**PLANNING COMMISSION REPORT**  
**Regular Agenda – Public Hearing Item**

**ITEM NO. 10C SPECIAL USE PERMIT FOR ASPEN HEIGHTS; 1900 W 31<sup>ST</sup> ST (SLD)**

**SUP-11-5-11:** Consider a Special Use Permit for Aspen Heights for the development of multiple detached dwelling structures on a single lot in an RM District as required by Section 20-402 of the Land Development Code. The property is located at 1900 W. 31<sup>st</sup> Street. Submitted by Landplan Engineering, for Mid-America Manufactured Housing Communities, Inc., property owner of record.

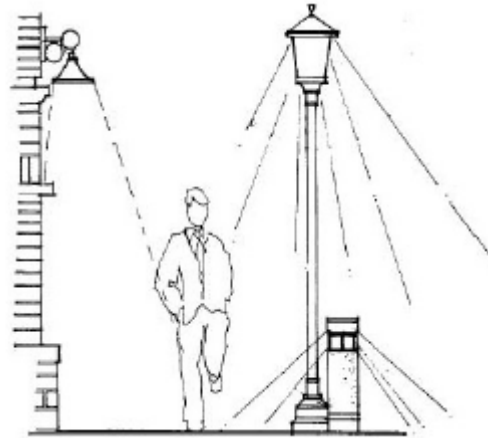
Much of the proposed development will be fenced. The use of the shared path follows a path along 31<sup>st</sup> Street then northbound along Ousdahl Road within public right-of-way. The path then extends to the east through the pedestrian easement and north to the north property line extending into Naismith Park. Fences and gates will inhibit movement and use of this path. Gates that allow pedestrian and bicycle movement shall be provided. Staff recommends that additional detail be provided to assure that fencing proposed for the site does not obstruct the multi-use path.

A graphic is attached that highlights the location of the multi-use path and interior sidewalks through the development and the two points where gates may conflict with access to the sidewalks.

- c. Provision of an exhibit designating minimum elevation of building openings for units adjacent to a drainage easement.
  - d. Provision of additional detail to assure that fencing proposed for the site does not obstruct the multi-use path.

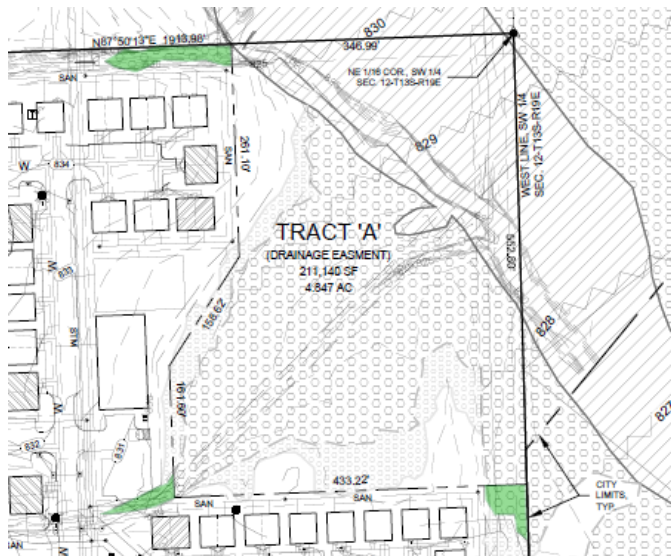
The plan notes that the parking lot will be lit by use of building mounted fixtures with 150 watt incandescent bulbs. A photometric plan is not required. Pedestrian scale lighting is recommended along interior pathways as a personal safety measure. Bollard and pole lighting are both effective options in providing location specific lighting. An example of this design recommendation is located in the City's *Community Design Manual, Section two: Commercial Development* (Commercial Design Guidelines) Page 2-22.

This type of lighting is recommended for the sidewalk extending north of Ousdahl Road, along the designated shared use path in the central portion of the site and the segment extending north along the clubhouse.

- a. Provision of a revised plan to include pedestrian lighting along interior sidewalks and the multi-use path.
  - b. Provision of an addressing scheme proposing distinct references for each building.
